ALL BAND SWITCHES SHOWN IN POSITION 5

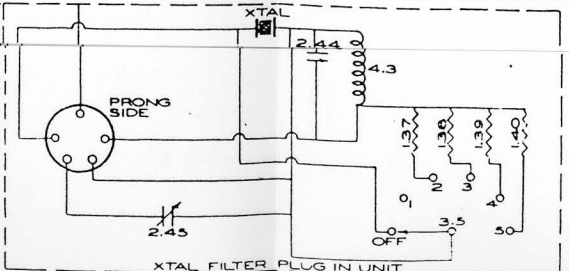
REVISED	EXPLANATION	DATE
A	Change in location of 53 pin	11/15/52
A	Lead on 115V tap removed	"
A	Changed as indicated	"
A	Moved from top of winding	"
A	Emphasizing spk. leads	"
A	Removed the spk. leads on 115V & 115K taps. THE CHANGE REMOVED FROM DRAWING	"
C	REV. R METER WIRING	"
C	REWORKING OF NOTE SILENCER	"
